# ONE SYDNEY HARBOUR

## BARANGAROO

R5 SUPPLEMENTARY DESIGN STATEMENT FOR S4.55 MODIFICATION - RESPONSE TO SUBMISSION  
March 2021

Proposed Sliding doors layout

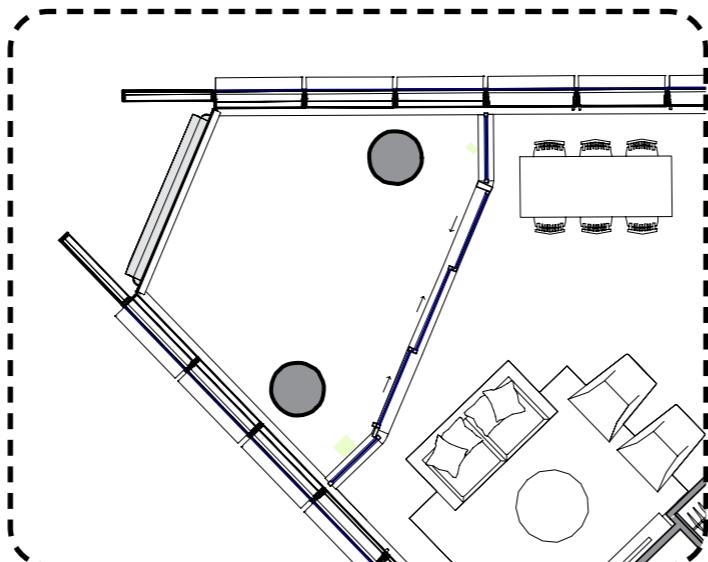
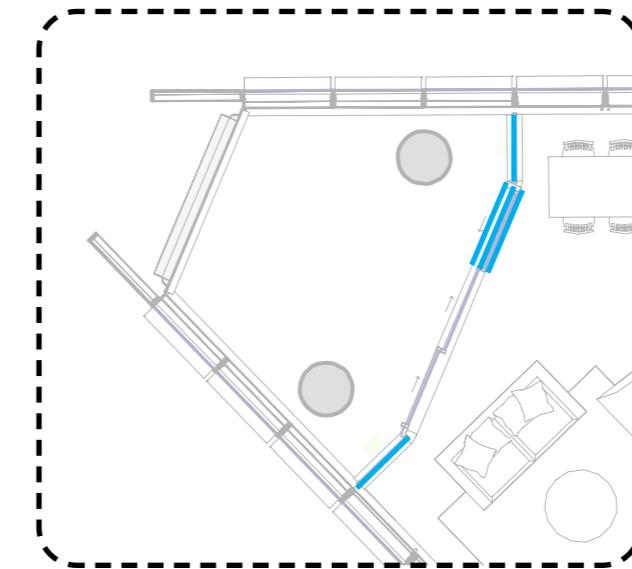
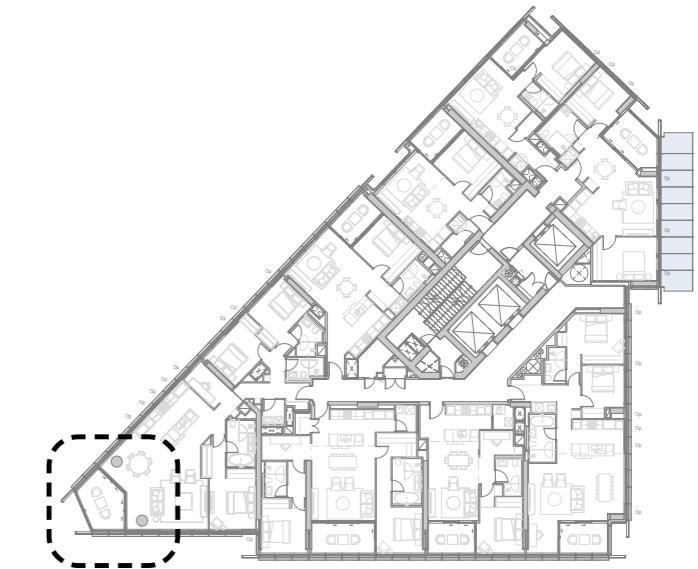
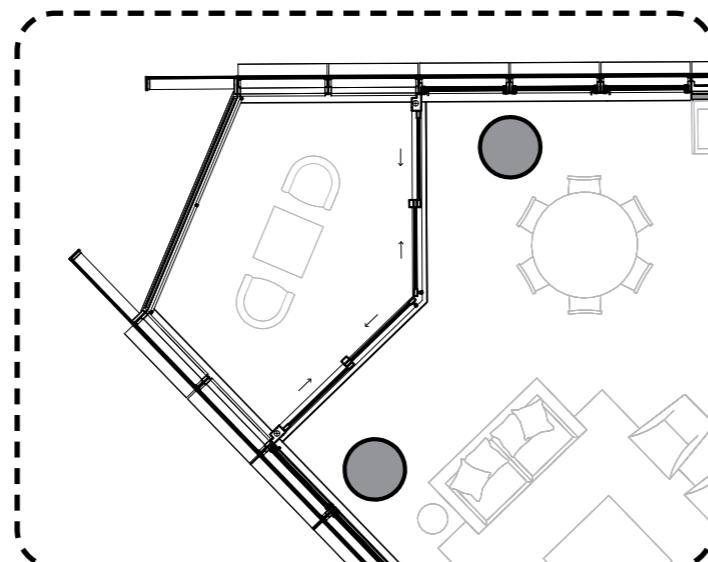
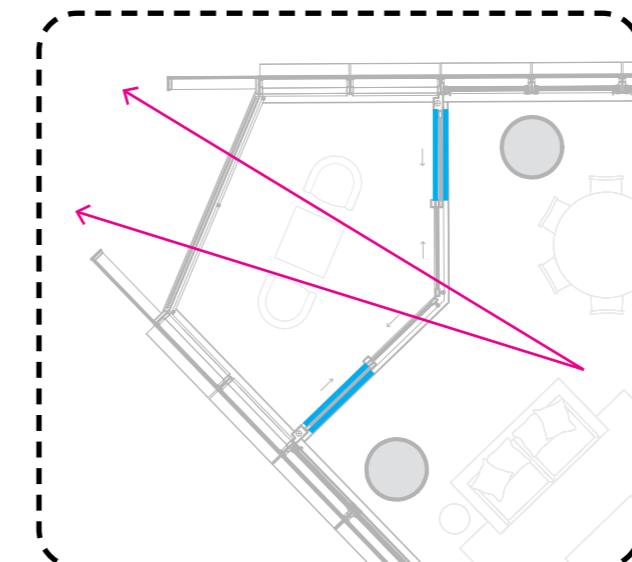
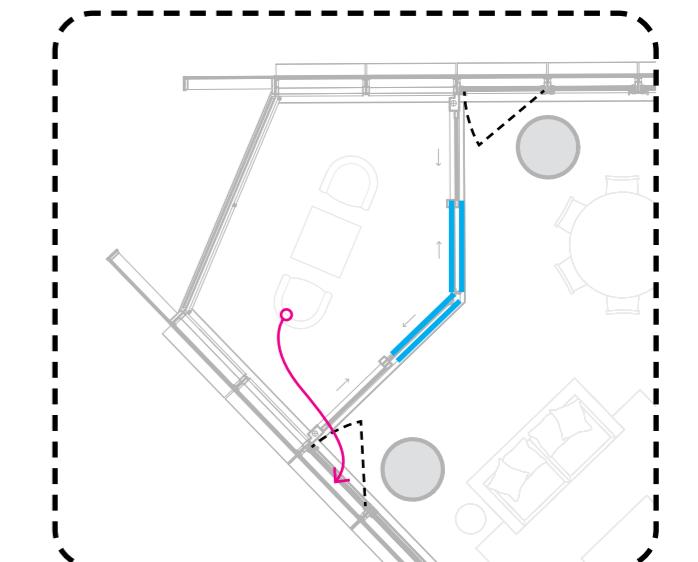
An amendment is proposed to the sliding doors arrangement of the apartment 01. This change is a consequence of the facade shift described on Section 2.1. The shift caused the tip to extend by one bay from the column grid.

Considering the design intent to have the columns free of connections that would undermine their perception and the requirement of 12m<sup>2</sup> in the balcony the doors arrangement had to be reviewed.

A last factor that was considered was the requirement of maintenance needs of the adjoining OCF facades. Such facades require access to their cavity for cleaning and for the blind's maintenance.

The proposed solution simplifies the door arrangements, removing the side fixed panels. By doing so, we can have the mid panels that are operable by the user, and the end panels, to be operated for maintenance only, creating a clean accessway to the OCF facade. Furthermore, this proposed scheme allows the doors to pack symmetrically away from the main line of sight, enhancing the connection between inside and outside.

Proposed Apt 01 (Tip) Balcony - Internal View

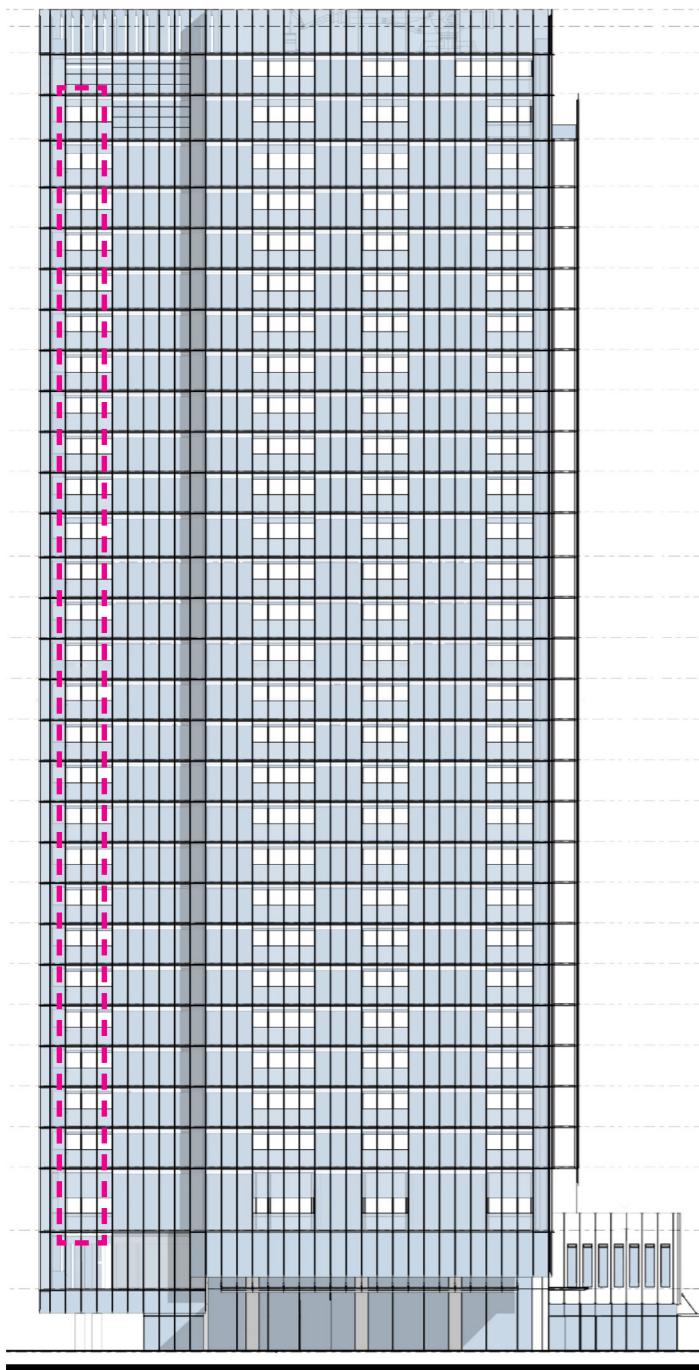
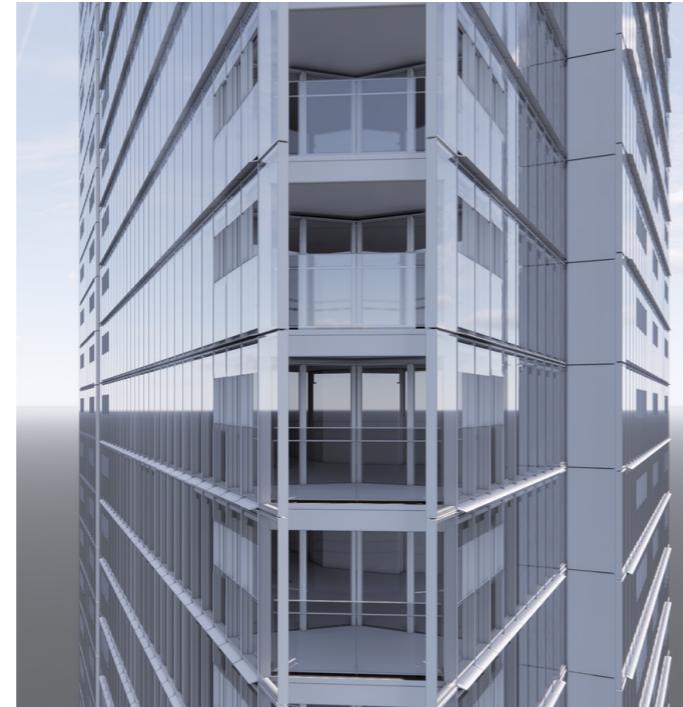
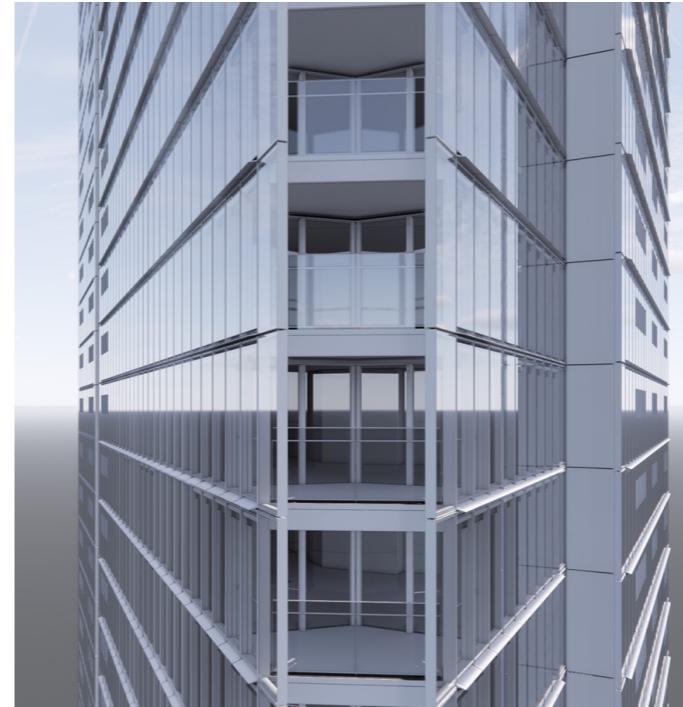
A minor adjustment is proposed to the balcony facade for Apartment 01 for all levels. Wind analysis has identified both a comfort and safety exceedance. As a result, if left unchanged, the residents will periodically experience uncomfortable conditions during high wind events.

To mitigate this issue, the facade balustrade glass is proposed to be extended floor to floor (full height) on both the eastern and western facades maintaining the symmetry of the northern most point of the tower form. No changes are proposed to the northern most balcony face which will remain open as shown in the following images. This semi-enclosure will ensure safe conditions are maintained on this balcony year-round.

Proposed SH Double Height Facade

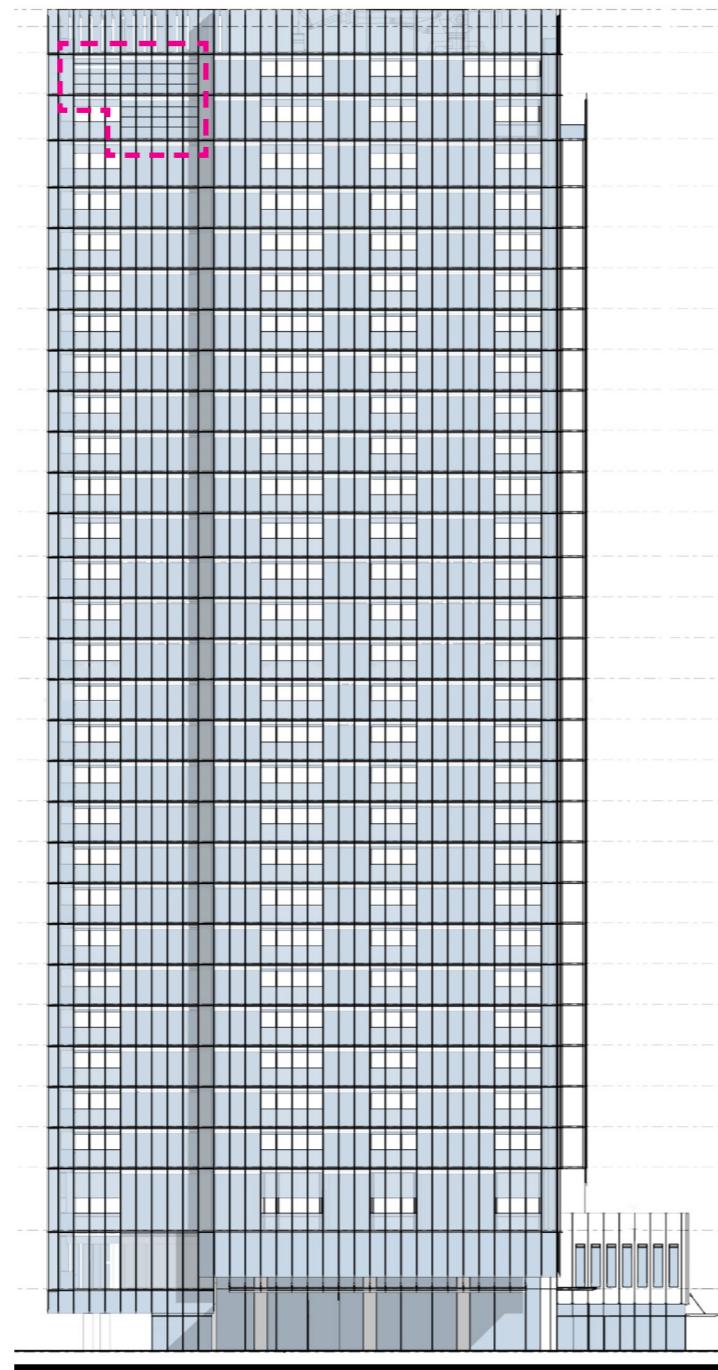
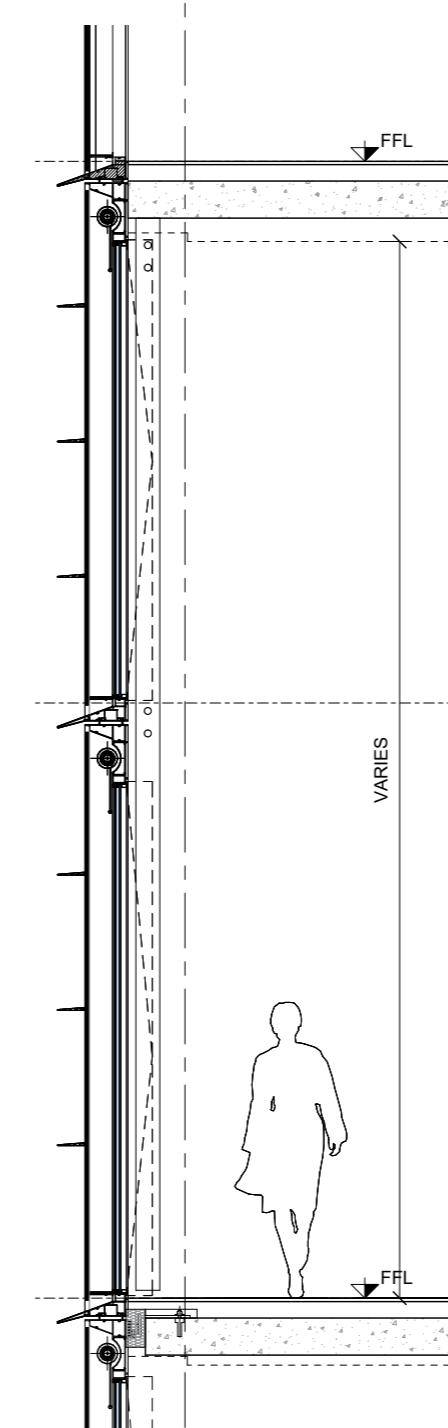
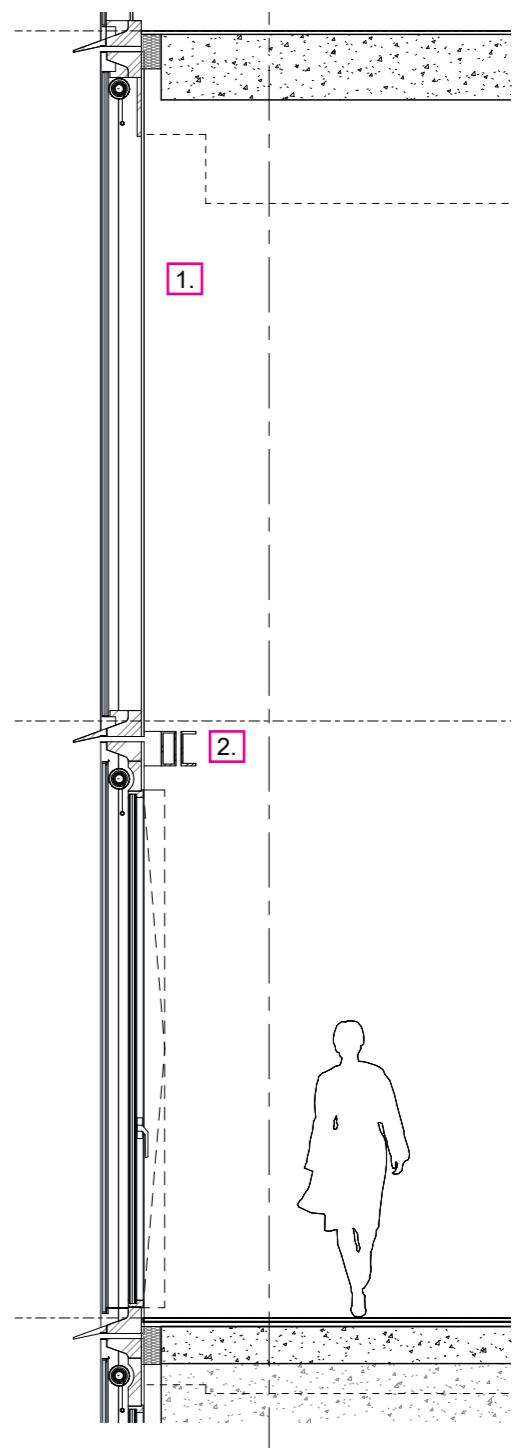
In the approved design, the area was envisaged with some horizontal brise-soleil facing both the Park and the Hickson Road facade.

In line with the development of the adjoining towers R4A and R4B, these elements are now proposed to be removed from the facade, allowing R5 to match its precinct neighbours.

Internally two adjustments are also proposed to match the similar situation in the R4A double height area.

1. The top panel of the space is changed from an Open Cavity Facade to a fixed Double Glazed Unit. This allows for easier and safer maintenance of these elements.

2. The backstructure has changed from vertical posts to a horizontal beam. This avoids potential clashes with the operable OCF panels swing and clear up the view from that space outwards.

Proposed Balcony Facade

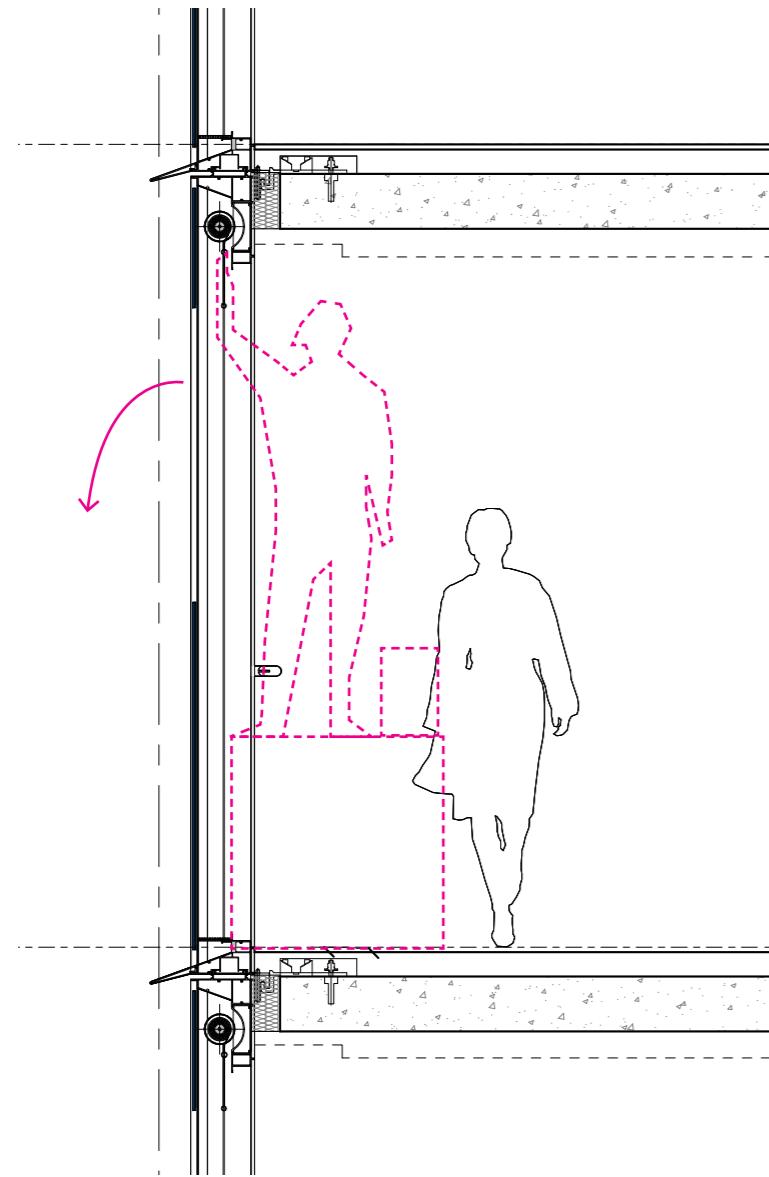
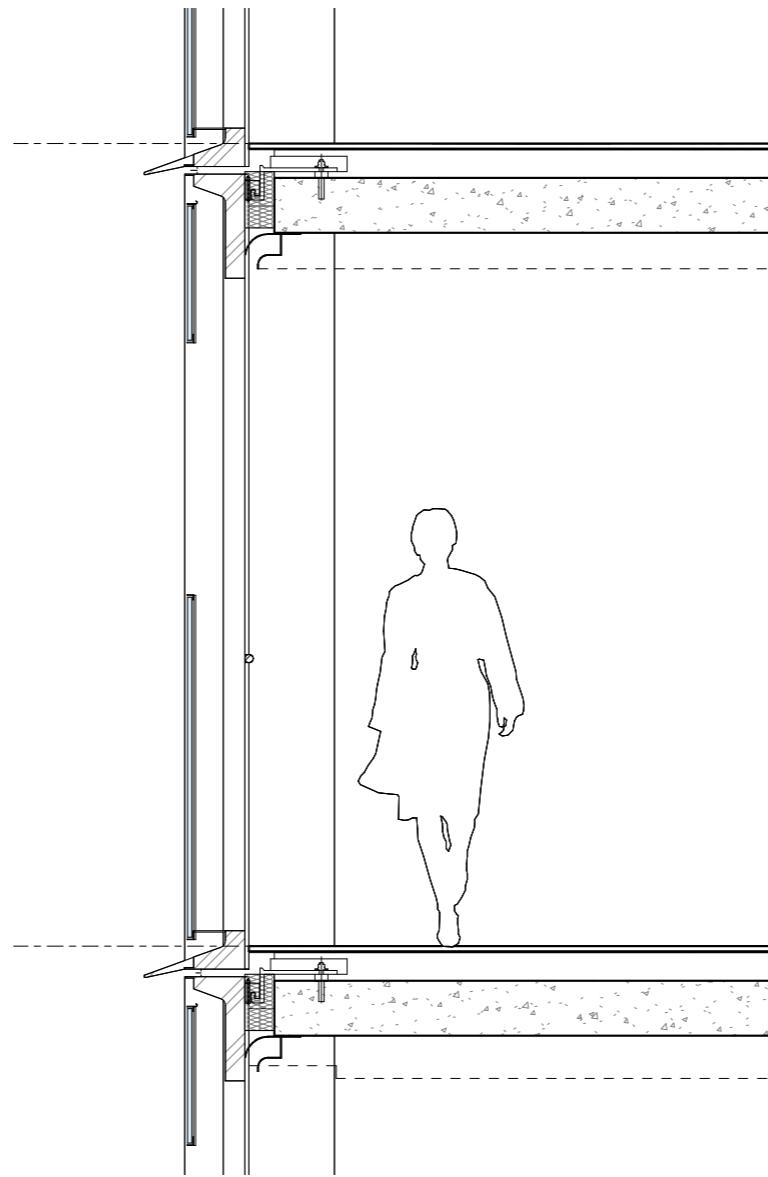
A safety and maintenance review of the balcony blinds has been undertaken.

The concern was that during a maintenance routine, the large balcony opening could represent a risk for the technician. To reach the blind level, a person would necessarily have to step on a platform or ladder, positioning themselves at the same level of the opening. In official maintenance routine this issue could be addressed by using safety nets and similar equipment and procedures. However, a concerning scenario would be in case of minor issues, where the residents could decide to investigate by themselves, ultimately exposing themselves without the official safety procedures. Furthermore, in both cases given the maintenance nature of the procedure it is also worth considering the risk of falling objects and tools while such work is undertaken.

With that risk in mind, it was understood that it would be safer not to have blinds in that location, effectively removing them from all balconies and with them the associated risks listed above.

Proposed R5 Cladding, simple folded element, more adequate to suit the various steps and notches

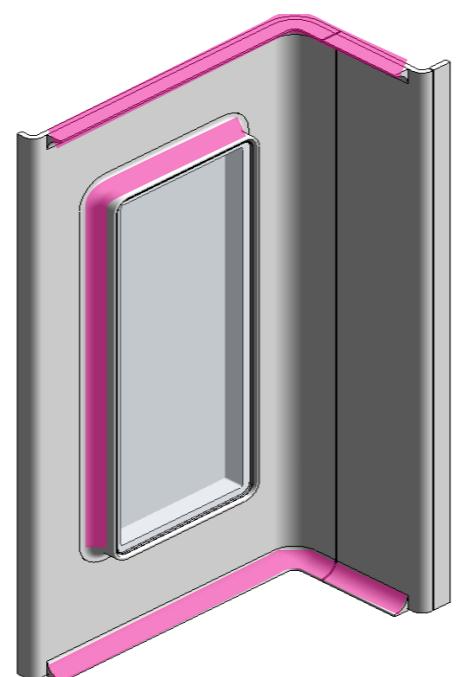
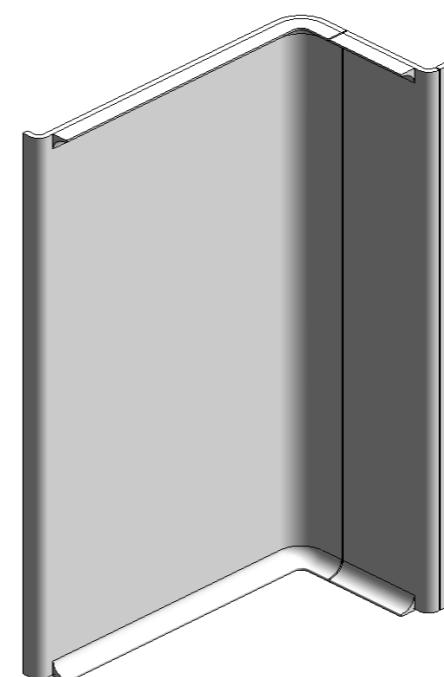
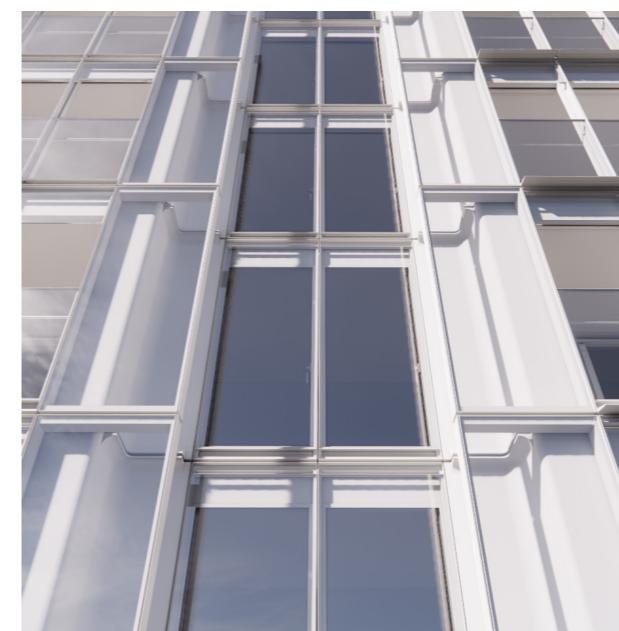
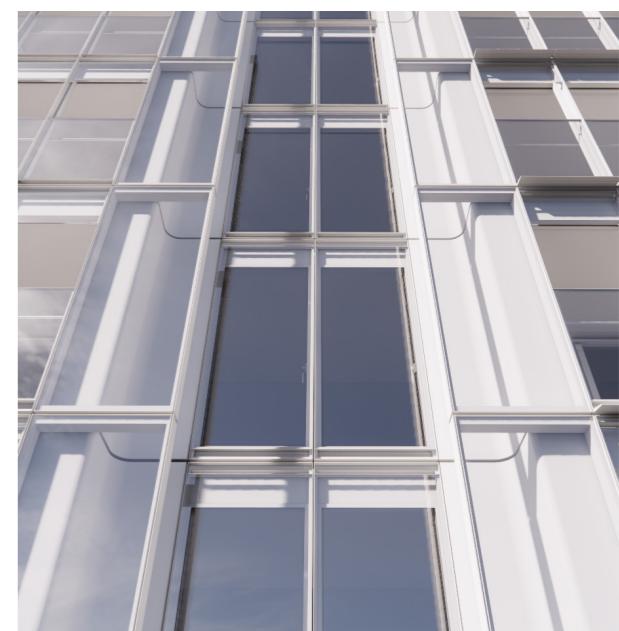
A minor adjustment is proposed to the facade claddings along the tower, removing their expressed horizontal "lips".

In the approved scheme, similarly to the adjoining R4A and R4B towers, such element was envisaged with bottom and upper lips as per following diagrams.

However, on these towers, such notches are different from R5's, since they feature a window element, main driver of the lip geometry (see magenta highlight in the first diagram).

This change is important when it is considered that that R5 has several differently shaped cladding elements in its arrangement, some of which, the lip's expression produced rather odd results given their small dimensions such as, but not limited to, the Hickson Road notch, where lips in the area renders the compressed space unnecessarily cluttered, as depicted in the following images.

By removing these lips and adopting a clean and simple folded element all around R5, we more adequately address the tower's specific steps and notches, highlighted in the schematic plan. We believe by doing so, we are able to affirm R5's uniqueness while still preserving a direct connection to the remaining precinct towers.
